Reference: Docket #'s: 52-014 and 52-015

Subject: April 3, 2008, Citizen Comment of Garry L. Morgan to Scoping Session,  
Environmental Impact Statement Bellefonte Nuclear Plant Units 3 and 4  
*COL Application, Environmental Report Omission*

Dunlopson 3-1

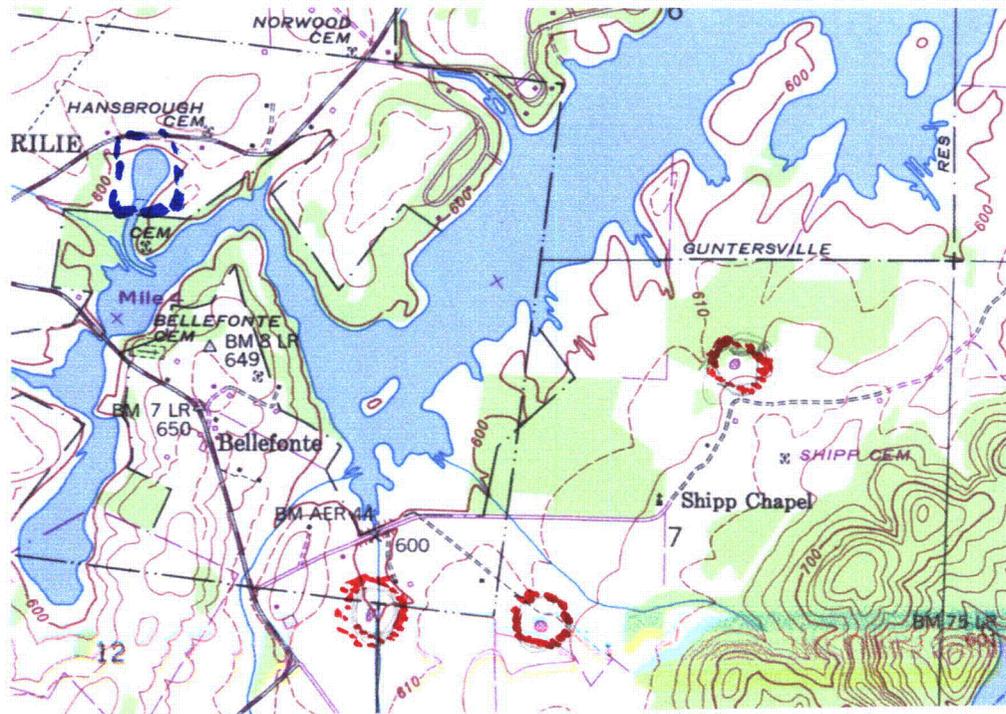
TVA's Environmental Report, Part 3, Hydrogeology, fails to consider historical maps of the area which clearly reflect sinkhole formation on and near the plant site, Inclosures 3-1 thru 4. The word Bellefonte means "beautiful spring.." The Environmental Report on page 2.3-24 states, "No springs were observed in the vicinity of BLN with the exception of small, seasonal and wet weather seeps with no measurable flow." On Inclosure 3-1 the historical "Bellefonte Spring" may be seen about 100 yards west southwest of the Hansbrough Cemetery and outlined in blue on inclosure.3-1 and 3-3, less than 1 mile from the plant site.

Inclosure H

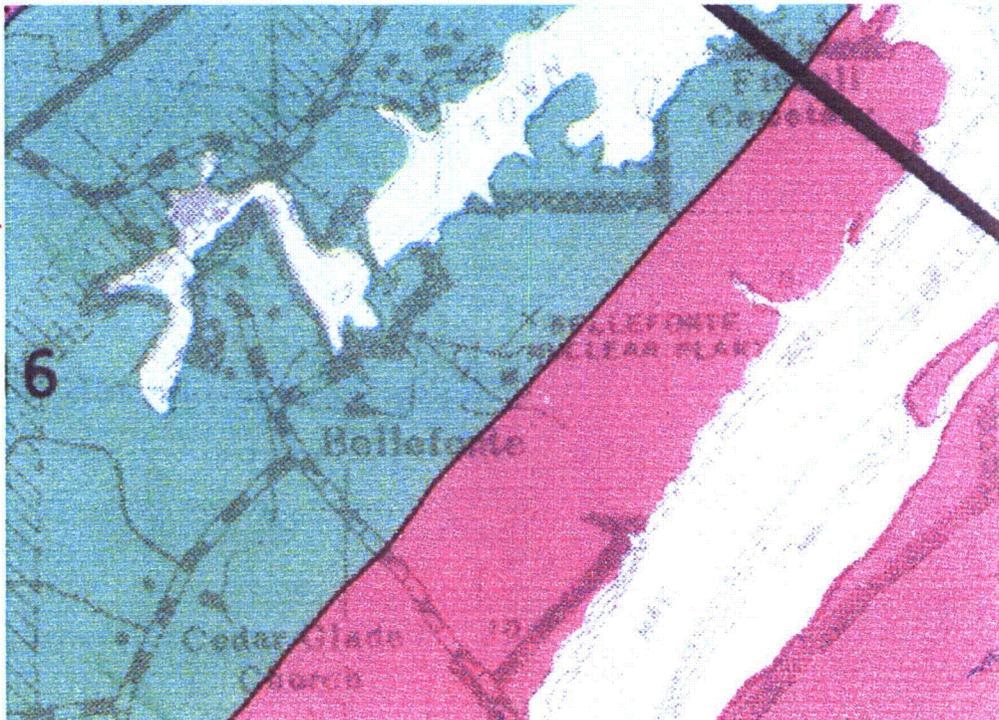
On page 2.3-23, Regional Hydrogeology, the Environmental Report states the aquifer systems of the area reflect a flow which "yields 10-50 gallons per minute, gpm, of water. Inclosure 4, 1989 Geological Survey of Alabama, Groundwater Availability Map of Jackson County reflects yields of 50-500 gpm.

*Incident 5-2*

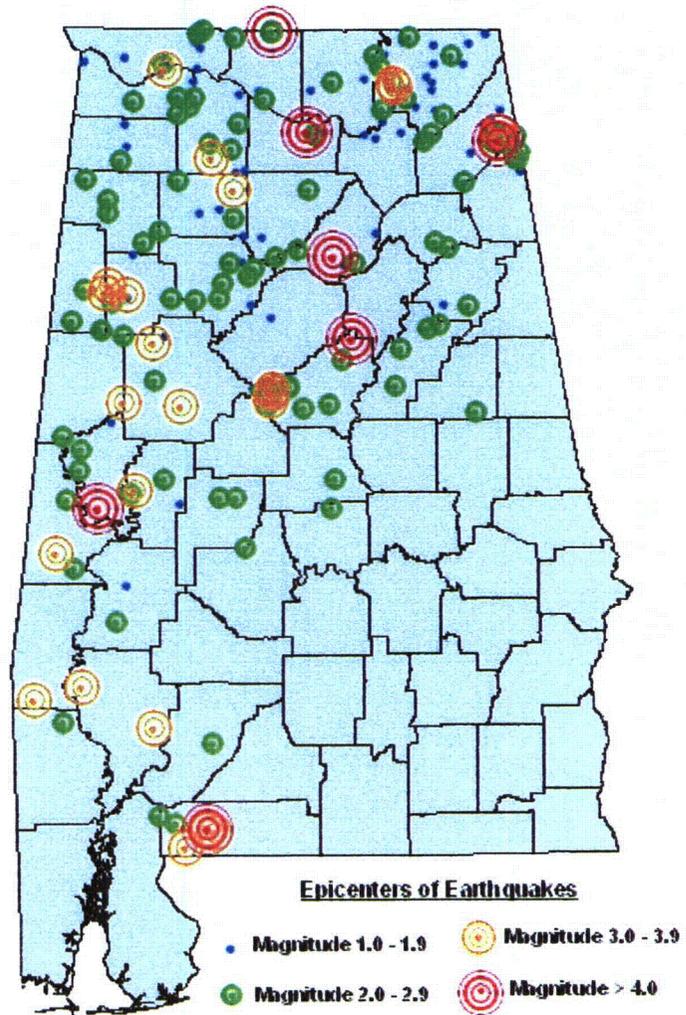
In the COL Application, Part 3, Environmental Report there is no mention of seismic activity and its effects on the "Karst Terrain." Immediately east of the Nuclear Plant is a ridge called River Ridge. River Ridge is a minor fault area. Inclosure 5-1 and 5-2 describes seismic activity in Alabama. If you will notice on the map at Inclosure 5-2 there are several minor earthquakes that have been historically recorded. Earthquake effects on the Karst Terrain have not been discussed in the Environmental Report.
